**AMENDMENT OF SOLICITATION/MODIFICATION OF CONTRACT**

2. AMENDMENT/MODIFICATION NO. <b>0002</b>	3. EFFECTIVE DATE <b>06 June 2008</b>	4. REQUISITION/PURCHASE REQ.	PROJECT NO. (If applicable) <b>P-1163 &amp; P1164</b>
--	--	------------------------------	--

14. DESCRIPTION OF AMENDMENT/MODIFICATION (Organized by UCF section headings, including solicitation/contract subject matter where feasible.  
**P1163 MAIN GATE PHYSICAL SECURITY UPGRADE MARINE CORPS BASE CAMP LEJEUNE, NORTH CAROLINA & P1164 PHYSICAL SECURITY UPGRADES -- PINEY GREEN, MARINE CORPS BASE CAMP LEJEUNE NORTH CAROLINA**

This Solicitation Amendment 0002 is issued to make corrections to the Technical Specifications issued with the Solicitation. The attached pages represent Technical Specification Amendment 0001 corrections to Technical Specifications 566826 & 566828 (specifically). The due date for proposals remains Monday, 23 June 2008 by 2:00 PM.

# Repave / Pave Old Saw Mill Road

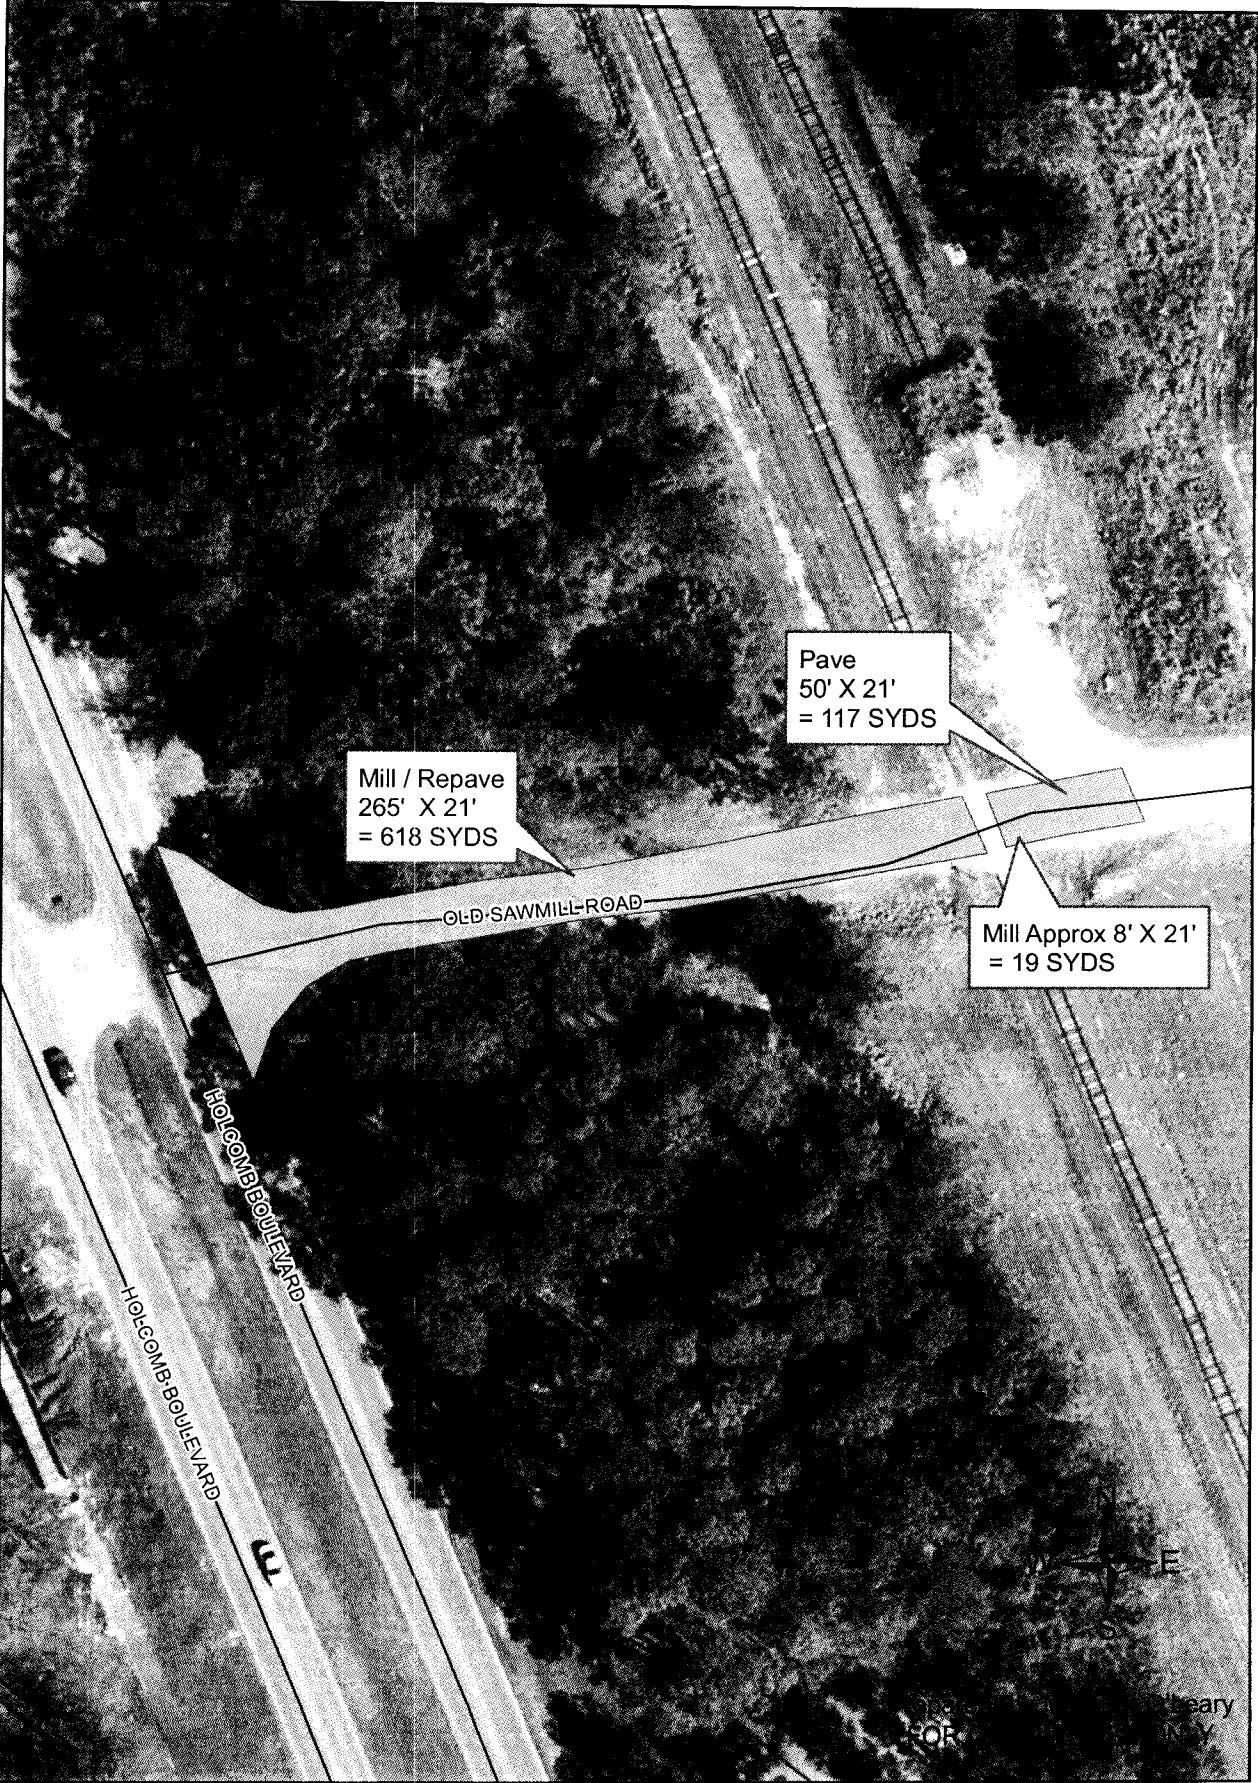
**ADD** the following paragraph at the end of the first paragraph:

"Note another Camp Lejeune project is currently under construction to pave a portion of Old Sawmill Road, approximately 315 feet of paving that extends from Holcomb Boulevard to 50 feet beyond the existing railroad tracks. See attached sketch. Coordinate with this construction project through the Contracting Officer."
